Groundwater Application Review Summary Form

Application # G- 18961 re-review

TO: Water Rights Section Date: 11/18/2022
 FROM: Groundwater Section Travis Brown
 Reviewer's Name
 SUBJECT: Application G- 18961 Supersedes review of 6/25/2020
 Date of Review(s)

A. GENERAL INFORMATION: Applicant's Name: Jane Stockfleth, LLC County: MARION

Theis (1935) Drawdown Analysis

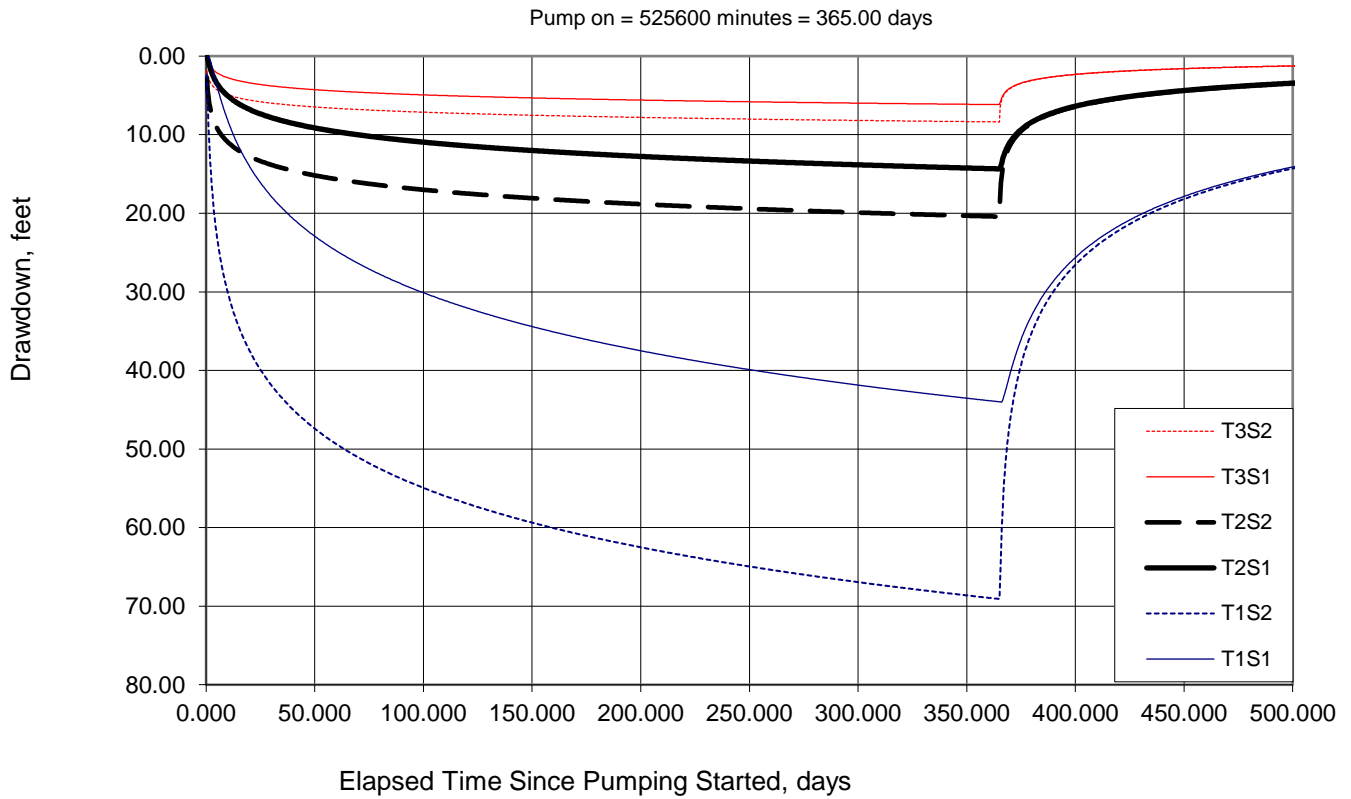
The nearest known neighboring well to the proposed POA (MARI 2540) is MARI 2541, ~1,020 ft southeast. MARI 2541 is the sole POA on Claim GR-92. Interference with MARI 2541 due to the proposed use was analyzed using the Theis (1935) solution for drawdown in a confined aquifer. Hydraulic parameters used for the analysis were derived from regional data and studies (Pumping Test Reports; Conlon et al., 2003, 2005; Iverson, 2002; McFarland and Morgan, 1996; Woodward et al., 1998) or are within a typical range of values for the given parameter within the hydrogeologic regime (Domenico and Mifflin, 1965; Freeze and Cherry, 1979; Halford and Kuniansky, 2002). Results of the analysis indicate the proposed use is unlikely to cause injury to MARI 2541 or similar neighboring wells (see attached Theis Drawdown Analysis).

Theis Drawdown and Recovery at r = 1020 ft From Pumping Well

Total pumping time: 365 days [season of use]

Pumping rate: 1.114 cfs [maximum combined rate (requested rate)]

Transmissivity: T1=700 ft²/d; T2=2900 ft²/d; T3=8000 ft²/d [pumping test reports]

Storativity: S1=0.01; S2=0.001 [Conlon et al., 2005]

Hydrograph

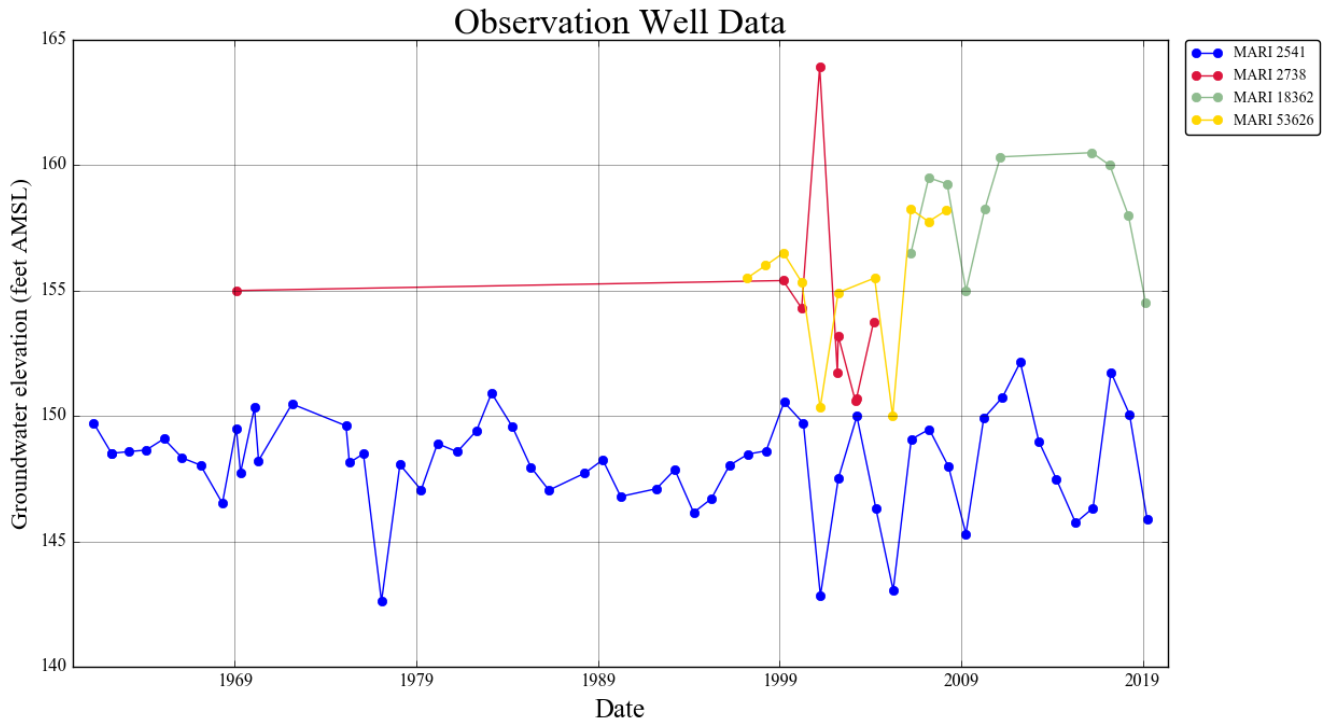
The proposed POA is completed on a terrace of Missoula Flood and older deposits and is confined by the fine-grained sediments of the Willamette Silt (Gannett and Caldwell, 1998; O'Connor et al., 2001). Geologic mapping in this area estimates the Willamette Silt as between 80-100 ft thick and the underlying sands and gravels of the Willamette Aquifer as ~40 ft thick (Gannett and Caldwell, 1998). However, the log for MARI 2540 indicates interbedded fine- and coarse-grained layers to its total depth of ~89 ft below land surface (bls). Nearby water level data does not indicate substantial persistent declines in the aquifer around the proposed POA (see attached Hydrograph). Therefore, groundwater in this aquifer appears to be not over-appropriated.

Stream Depletion Analysis: POA 4 – SW 2

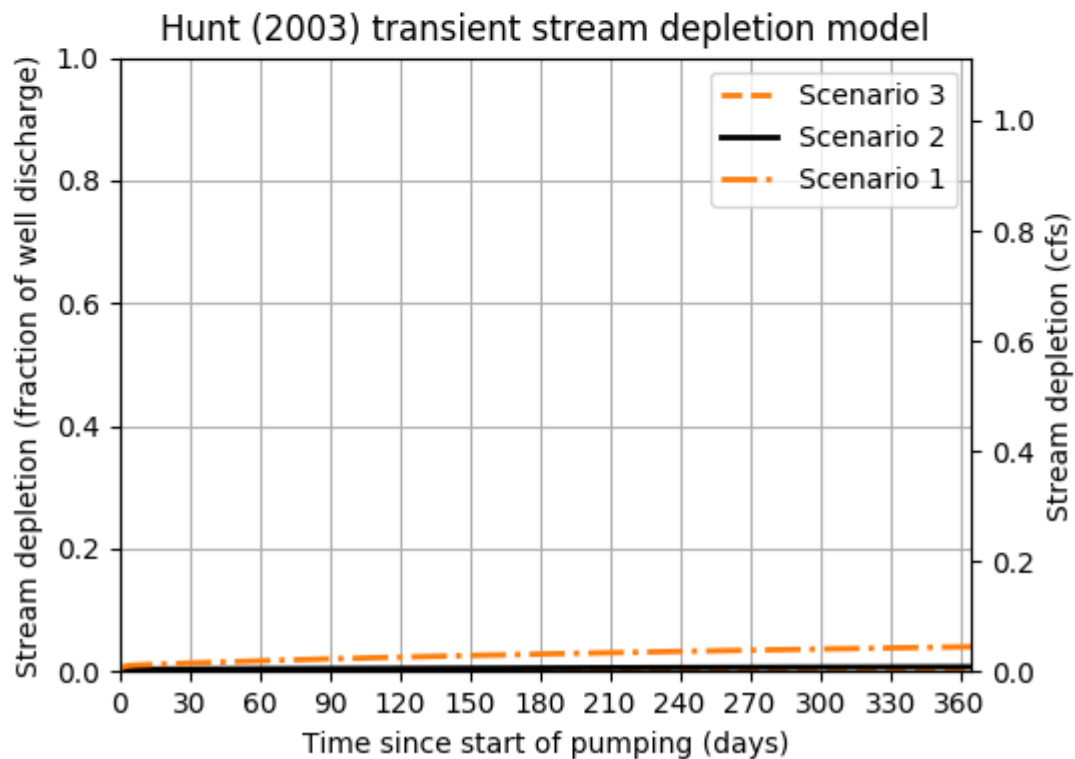
Comments: The proposed POA (MARI 2540) is within ¼ mile of SW 2. Per OAR 690-009-0040(a), the Potential for Substantial Interference (PSI) is assumed.

Interference with various surface water sources due to the proposed use was quantitatively estimated using the Hunt (2003) analytical model. Hydraulic parameters used for the analysis were derived from regional data and studies (Pumping Test Reports; Conlon et al., 2003, 2005; Iverson, 2002; McFarland and Morgan, 1996; Woodward et al., 1998) or are within a typical range of values for the given parameter within the hydrogeologic regime (Domenico and Mifflin, 1965; Freeze and Cherry, 1979; Halford and Kuniansky, 2002). Results indicate that the proposed POA is not anticipated to interfere with (deplete) nearby surface water sources at a rate greater than 25 percent of the rate of withdrawal within the first 30 days of continuous pumping.

Days	10	30	60	90	120	150	180	210	240	270	300	330	360
Depletion (%)	0	0	0	0	1	1	1	1	1	1	1	1	1
Depletion (cfs)	0.00	0.00	0.00	0.01	0.01	0.01	0.01	0.01	0.01	0.01	0.01	0.01	0.01

Stream Depletion Analysis: POA 4 – SW 4

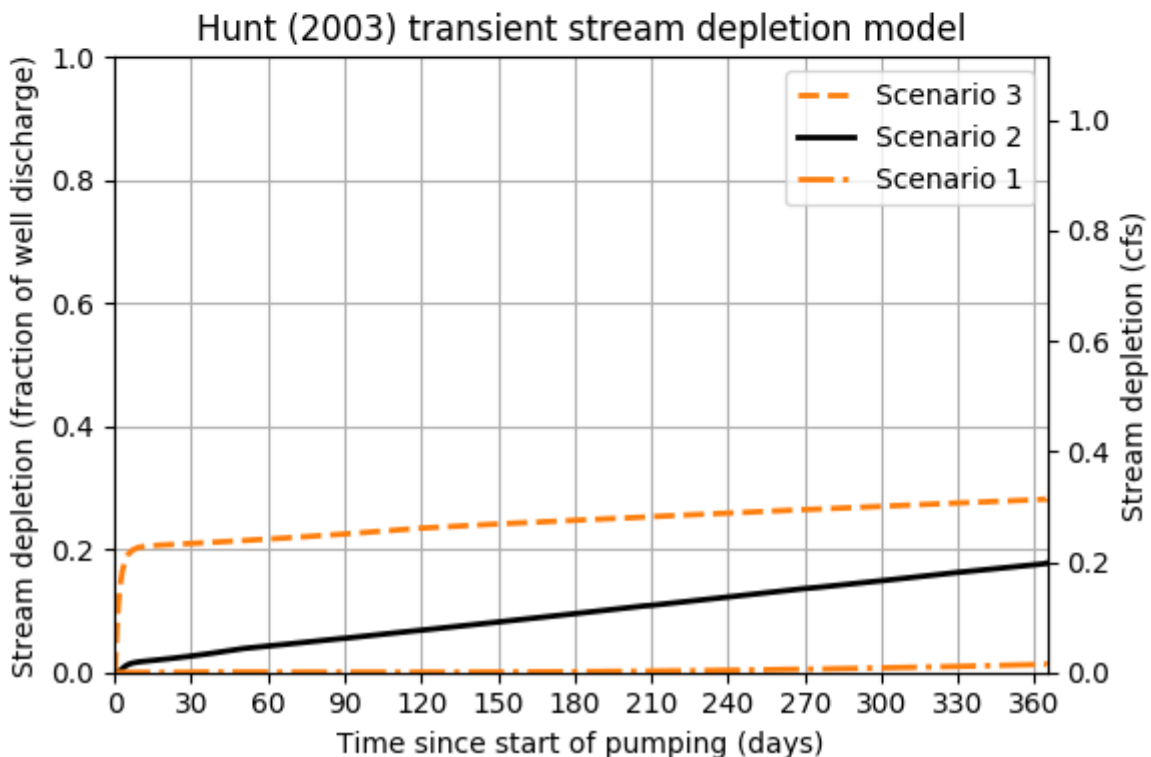
Days	10	30	60	90	120	150	180	210	240	270	300	330	360
Depletion (%)	2	3	4	6	7	8	10	11	12	14	15	16	17
Depletion (cfs)	0.02	0.03	0.05	0.06	0.08	0.09	0.11	0.12	0.14	0.15	0.17	0.18	0.19
